924123

CITY OF PORTLAND, MAINE
Department of Building Inspection

RE: Request for Certificate of Occupancy
35 Robin Street

Your application to install a 26.5'x48' manufactured home has been reviewed and a permit is herewith issued subject to the following requirements:

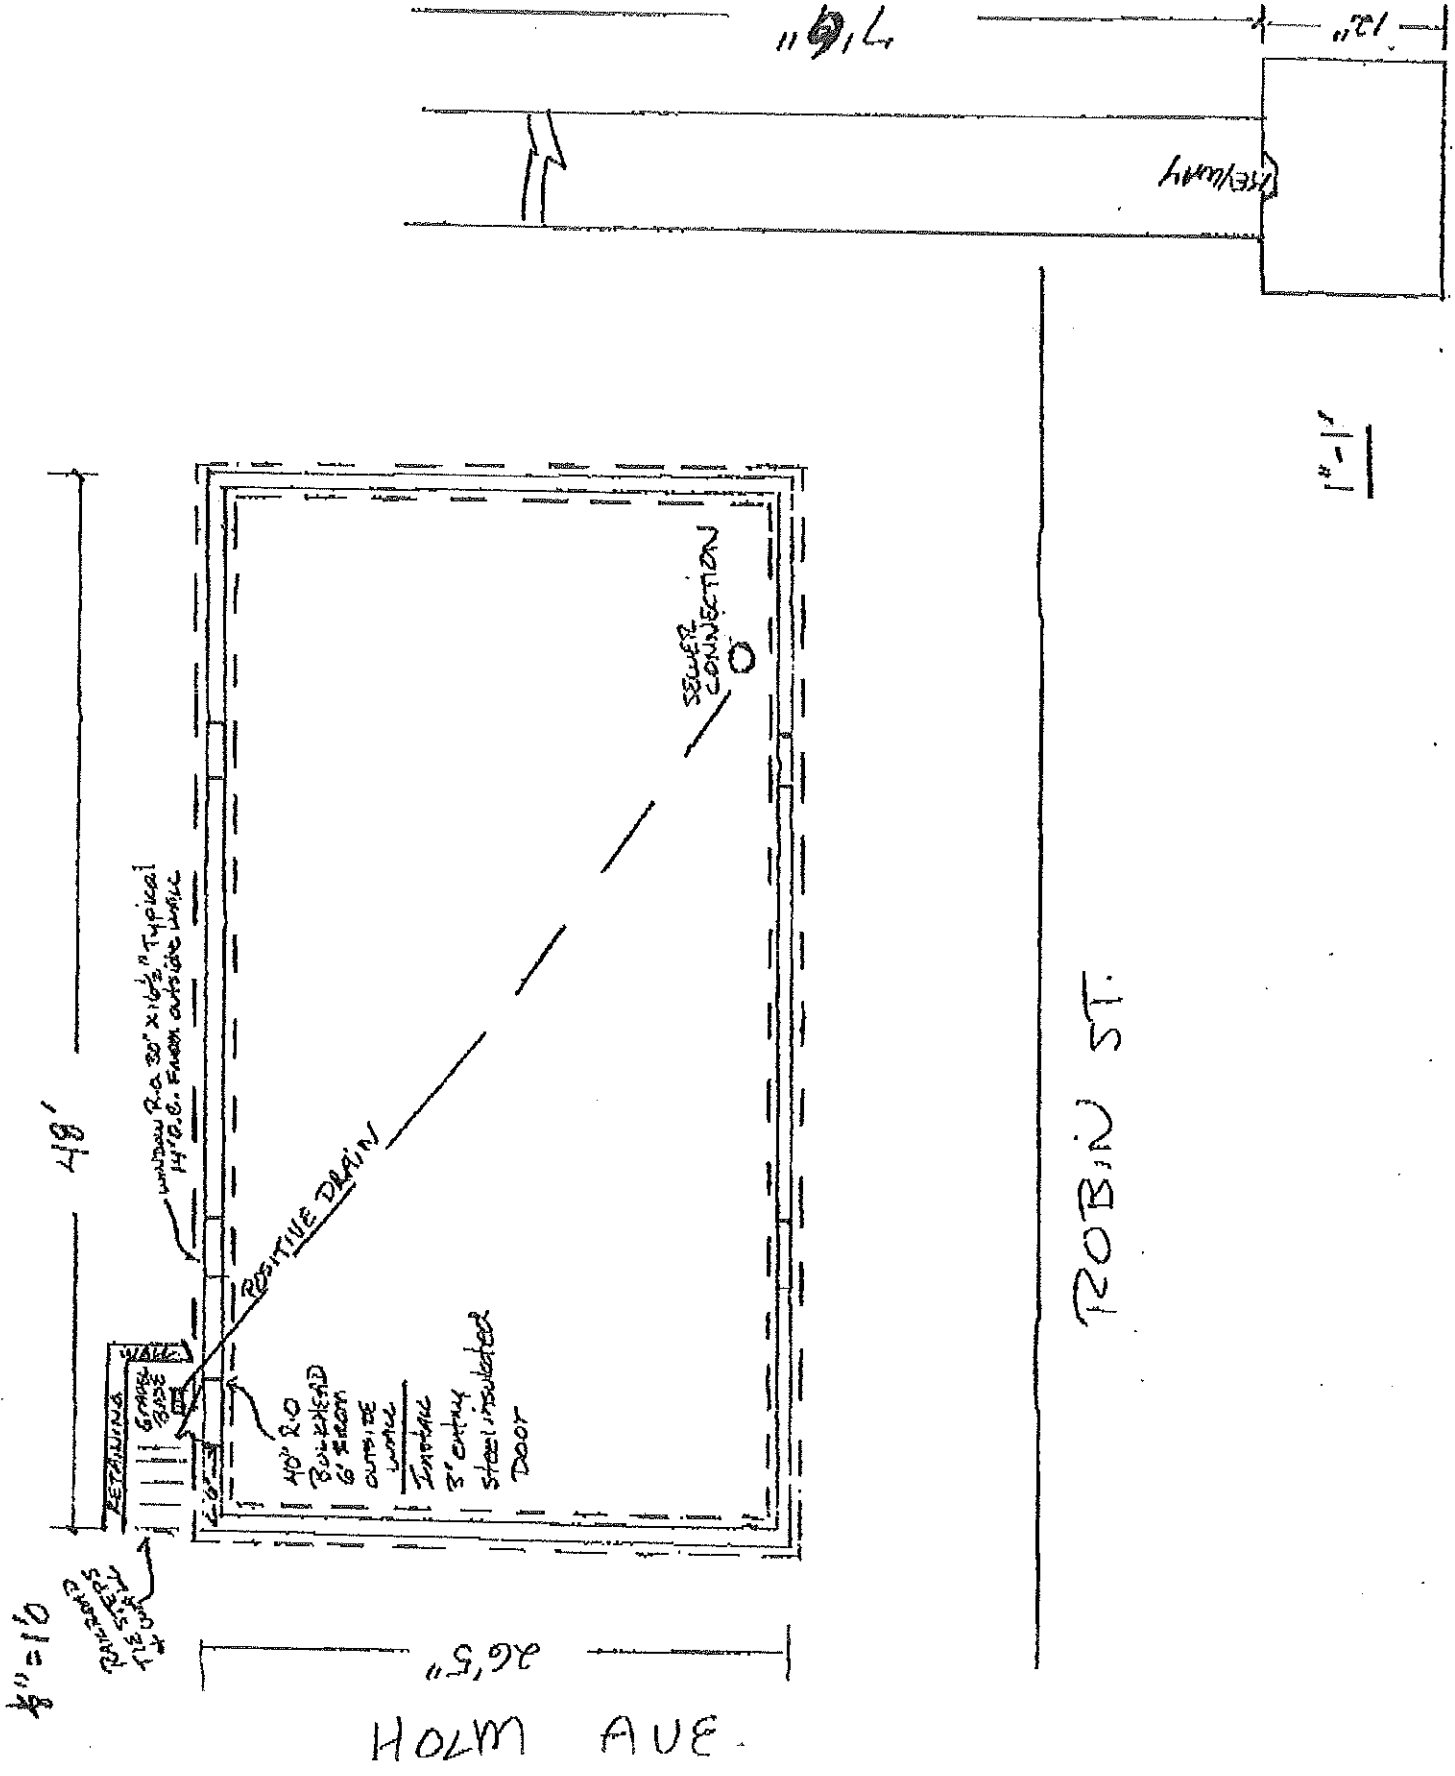
REMARKS: we are proposing an entry door rather than a bulkhead with a retaining wall built out on railroad ties and railroad tie steps. At the base will be a catch basin with a positive drain run to the sewer connection. Please let me know if this is acceptable, thanks. Bill Brown
